General Bid Bulletin No. 16
23 July 2021

**THE MALOLOS-CLARK RAILWAY PROJECT AND THE NORTH-SOUTH RAILWAY
PROJECT SOUTH LINE COMMUTER PACKAGE CP NS-01: PROCUREMENT OF
ELECTRICAL AND MECHANICAL SYSTEMS AND TRACK WORKS (IFB No: 21-040-3)**

This General Bid Bulletin is issued to amend/clarify certain provisions in the Bidding Documents for the above-mentioned Project. Please refer to the attached Annexes of this General Bid Bulletin for details:

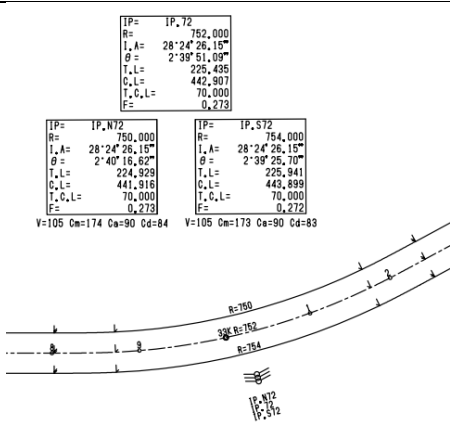
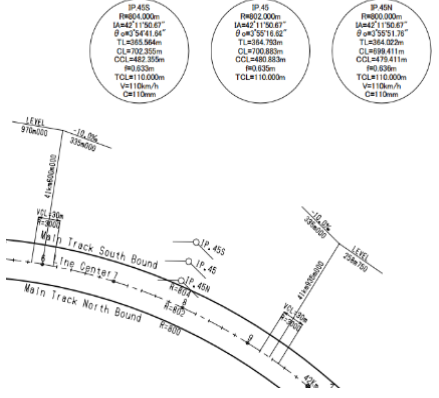
81	Volume II and III Section VI, 5b_Page 235 of 315 & ERT 13, NSRP-SW-ALT-SK-D-0003 & 1.6.1.7), 1.6.1.7) Maximum cant deficiency: 70 mm NSRP-SW-ALT-SK-D-0003	Bidder found that the reference drawing provided is not complying with ITB requirement itself and would like to clarify which document shall prevail. For example, in the ITB drawing, Cd designed for IP72, IPS72 and IP N72 is more than 70 mm which is deviating to the requirement in ERT 1.6.1.7). Bidder did the preliminary assessment and calculation and found cant deficiency can be brought less than 70 mm only by reducing Ca to		The maximum cant deficiency on NSRP was set to 90 mm. The difference of the maximum cant deficiency of MCRP is due to the difference in maximum design speed. In MCRP, the specification about maximum cant deficiency is set to 70 mm for high-speed operation. Please refer to Annex B

Item No.	Volume Section No. Page No. Clause No. / Title Reference Text	Clarification Request	Proposed Revised Text (if any)	Response
	 <p>IP= IP, 72 R= 752,000 I, A= 28°24'26,15" θ = 2°38'51,09" T, L= 225,435 C, L= 442,907 T, C, L= 70,000 E= 0,273</p> <p>IP= IP, N72 R= 750,000 I, A= 28°24'26,15" θ = 2°40'16,62" T, L= 224,929 C, L= 441,916 T, C, L= 70,000 E= 0,273 V=105 Cm=174 Ca=90 Cd=84</p> <p>IP= IP, S72 R= 754,000 I, A= 28°24'26,15" θ = 2°39'25,70" T, L= 225,941 C, L= 443,899 T, C, L= 70,000 E= 0,273 V=105 Cm=173 Ca=90 Cd=83</p>	<p>70 mm and Speed to 95 kph.</p> <p>There are several points inside the ITB drawing, where such deviations are found and would like to clarify which document shall prevail for the design.</p> <p>It is also to be noted that, speed could not able to follow as ITB requirement where such condition cannot be fulfilled.</p> <p>Please clarify.</p>		
82	<p>Volume II and III Section VI, 5b_Page 12 of 315, MCRP-DWG-ALT01-SK-0003, MCRP- DWG-ALT01-SK-0003</p>	<p>There are some curves in MCRP packages where the transition length and applied cant is not sufficient for rate of change of cant to be less than 29 mm/s. (Referring to the Technical Regulatory Standards on Japanese Railways (Civil Engineering))</p> <p><As an example, IP45, IP45S and IP 45N will have compliant to the rate of change of cant only when min. TCL = 111 m, Ca = 70 mm and 105 Km/h as speed (In ITB drawing, TCL =110 m, Ca=110mm, Speed =110Kmph).</p>		<p>Rate of change of can't to be less than 29 mm/s. (Referring to the Technical Regulatory Standards on Japanese Railways (Civil Engineering)) is based on the assumption that it will be applied to Ordinary Railways in Japan. And this sentence is a Reference. The original calculated gauge for this Rate is 1067mm in Japan. And MCRP is 1435mm gauge. The applicable calculation formula differs depending on the gauge.</p>

Item No.	Volume Section No. Page No. Clause No. / Title Reference Text	Clarification Request	Proposed Revised Text (if any)	Response
		<p>Bidder found that if such ITB requirement to be followed with given speed, shift of geometry (Transverse direction) around 12 mm is expected. ></p> <p>Bidder would like to propose; such horizontal shift in track alignment. If such shift shall not consider, a reduction of speed, modification of cant will be expected. Bidder expects such deviation may found in several locations.</p> <p>Please confirm that this methodology is acceptable.</p> <p>It is to be noted that either compromising to the shift or reduction of speed is expected. Bidder believes that the Civil construction work has already been finished and if any deviation to the current provided alignment may affect to the civil structure.</p>		<p>Note that in the calculation of Cant and Transition curve length for MCRP, the gauge value is calculated as 1500mm, which is the safe side.</p>

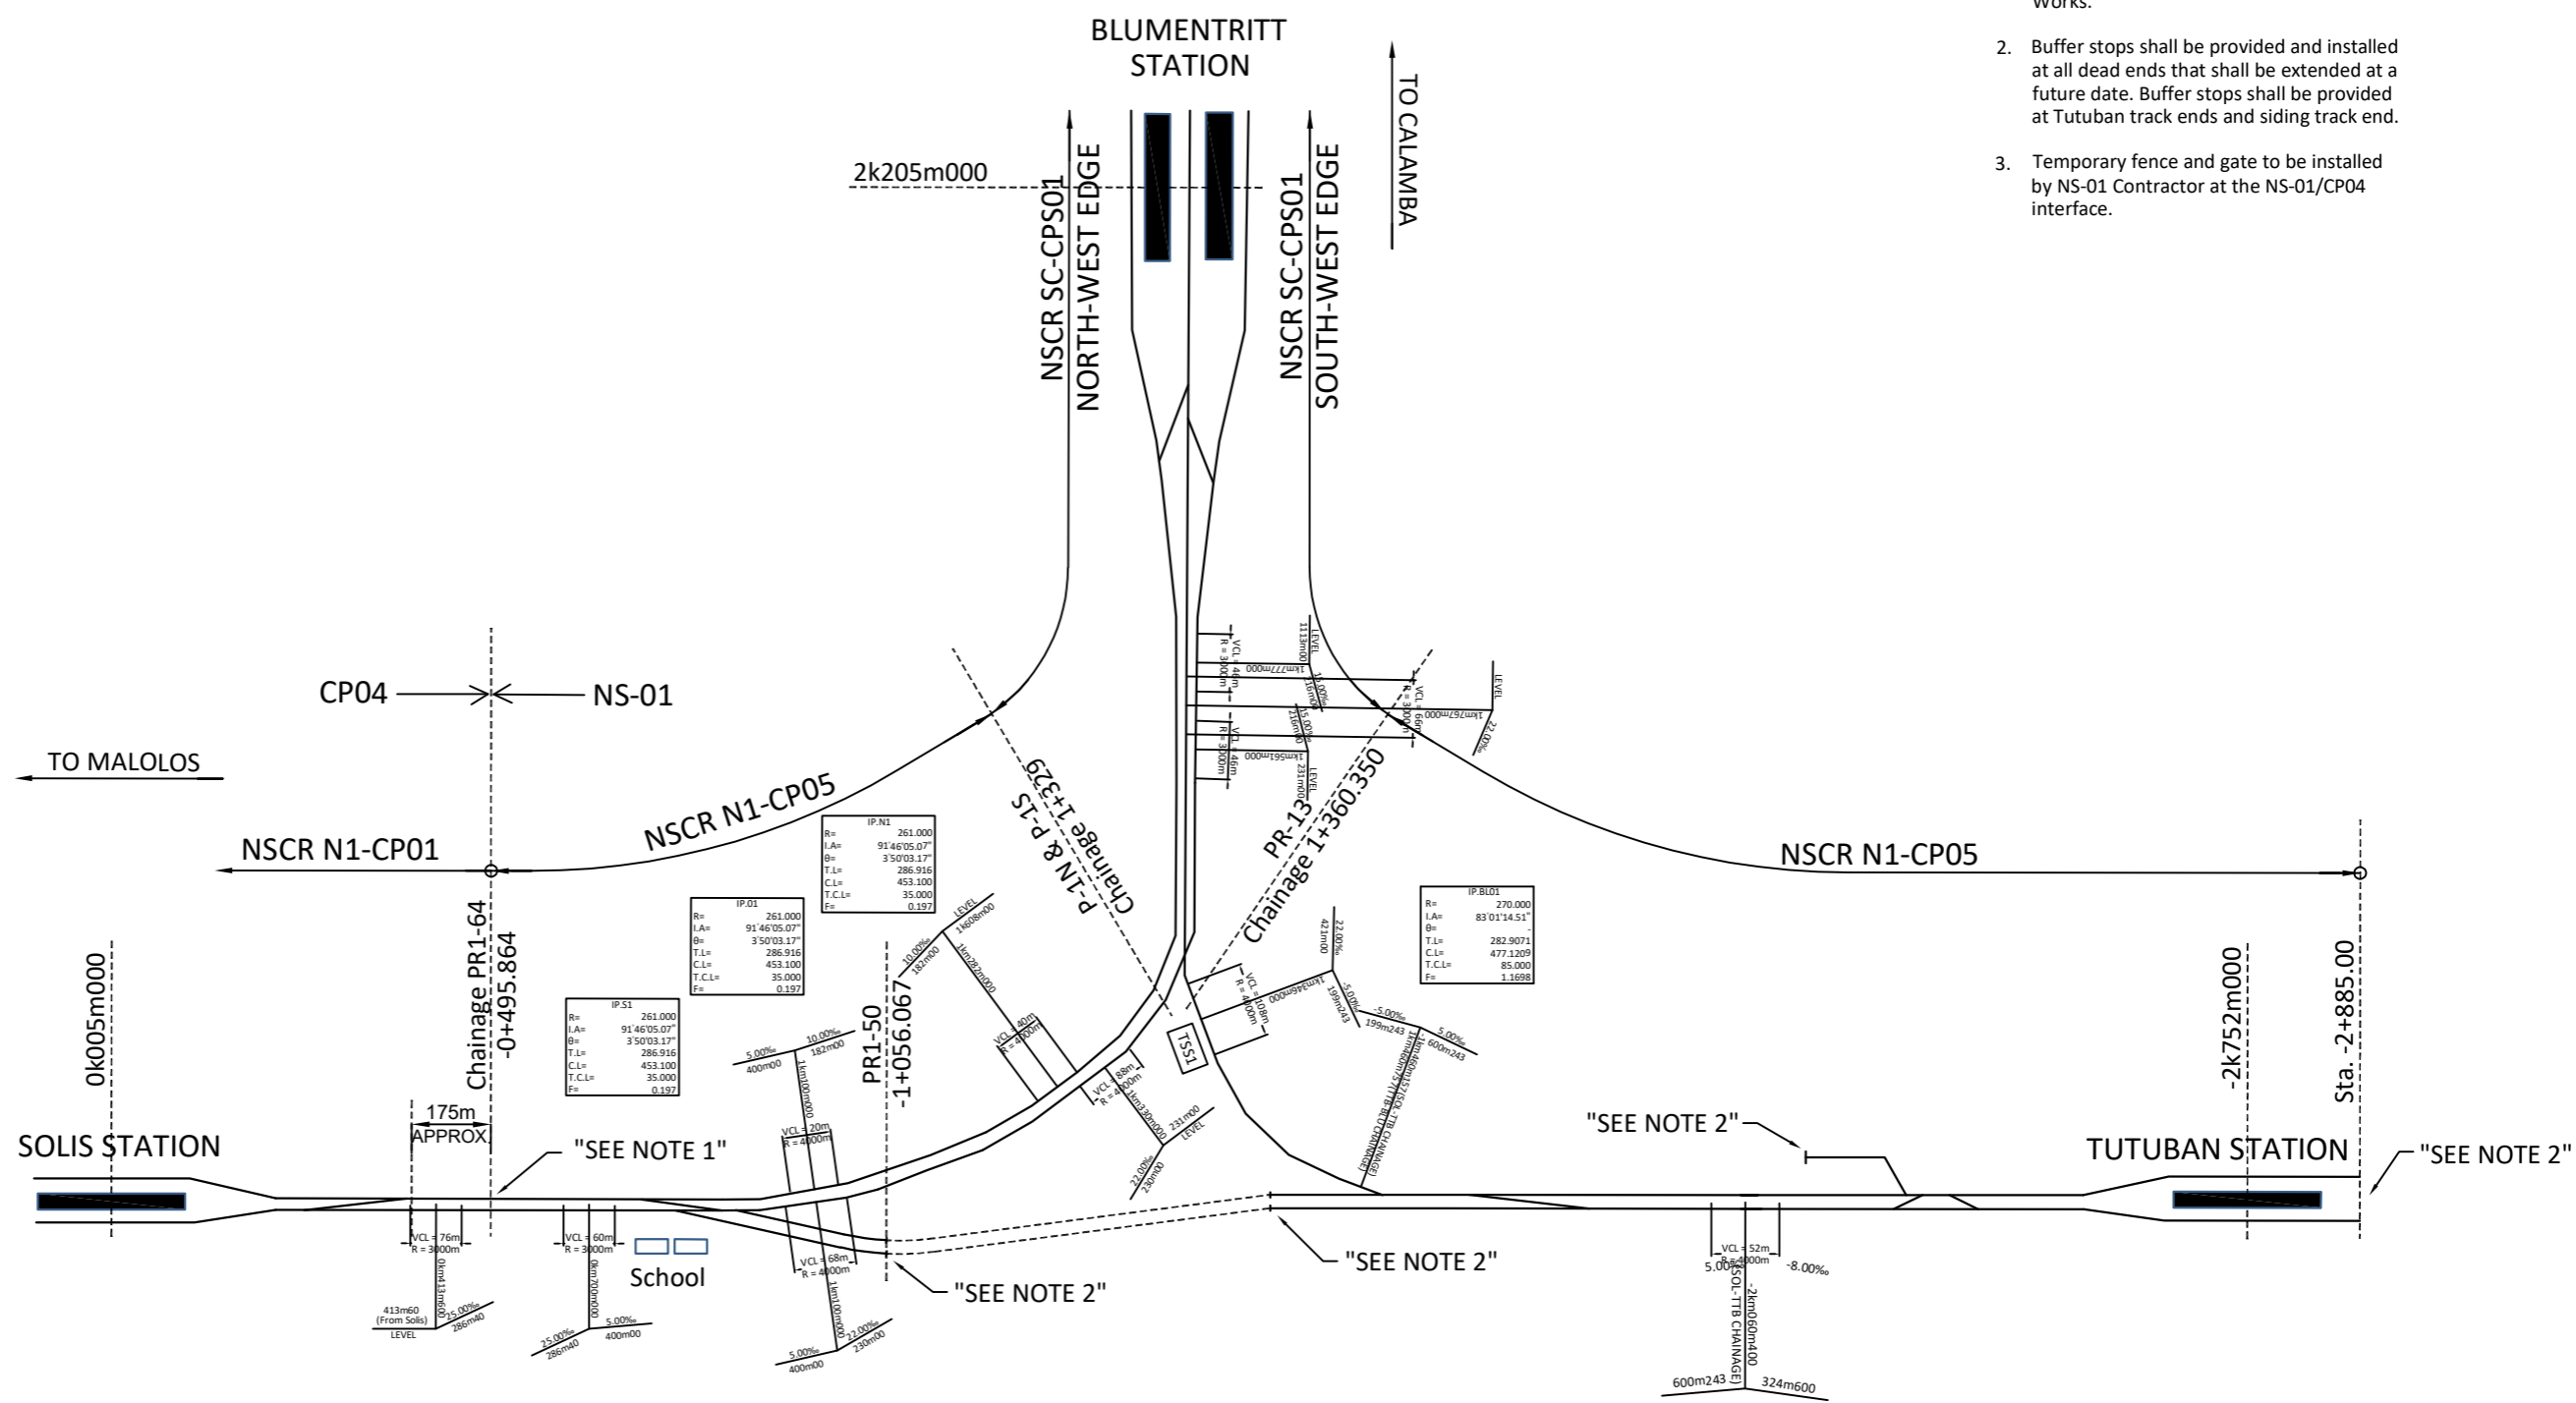
Volume III Part 2 – Employer’s Requirements d) Employer’s Drawings		
23	NSCR-GCR-NS01-SBT-DWG-TK-000001 GBB 5, page 53	SBT Drawing issued in GBB 5 is replaced by NSCR-GCR-NS01-SBT-DWG-TK-000001 Rev. 01

DATE	MAY 2021
SCALE	AS SHOWN IN A1
SHEET No.	1 OF 1
DRG No.	NSCR-GCR-NS01-ZWE-DWG-DS-000002
DRG S.	REV 01

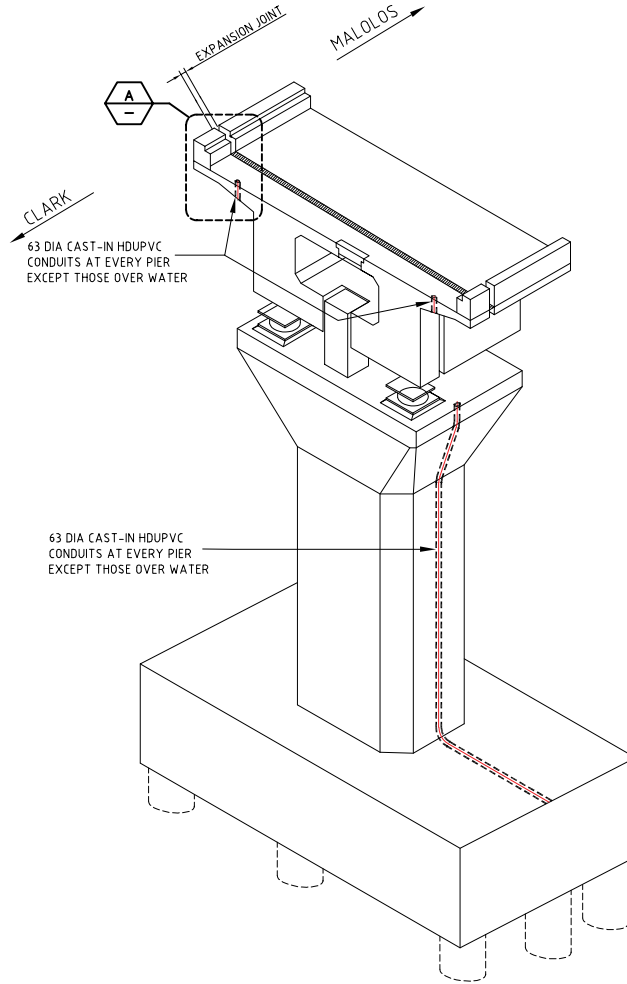
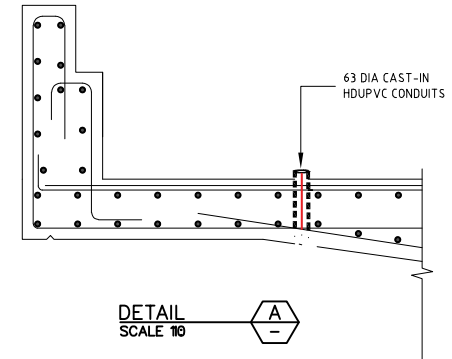
24	NSCR-GCR-NS01-ZWE-DWG-DS-000002 GBB 4, page 351	Lightning Arrester Detail issued in GBB 4 is replaced by NSCR-GCR-NS01-ZWE-DWG-DS-000002 Rev. 01
25	NSRP-South-DWG-X/X-OCS-0002 Rev. 04 GBB 12, page 239	Revised the drawing issued in GBB12 with drawing "NSRP-South-DWG-X/X-OCS-0002 Rev. 06"
26	MCRP-DWG-X/X-OCS-0002 Rev. 04 GBB 12, page 237	Revised the drawing issued in GBB12 with drawing "MCRP-DWG-X/X-OCS-0002 Rev. 05"

1. ALL CONDUCTORS AND EARTH RODS TO BE SUPPLIED AND INSTALLED BY CP NS-01 E&M CONTRACTOR.
2. ALL CONDUITS AND DUCTS TO BE PROVIDED WITH SUITABLE DRAW STRINGS.
3. EARTH RODS AND INSPECTION PITS PROVIDED BY THE CP NS-01 E&M CONTRACTOR SHALL BE EQUIPPED WITH SECURE LOCKABLE COVER.
4. THE ARRANGEMENT SHOWN ON THIS DRAWING IS INDICATIVE ONLY. THE CIVIL WORKS CONTRACTOR SHALL COORDINATE FURTHER DETAILS WITH CP NS-01 E&M CONTRACTOR PRIOR TO COMMENCEMENT OF THE RELEVANT CIVIL WORKS.
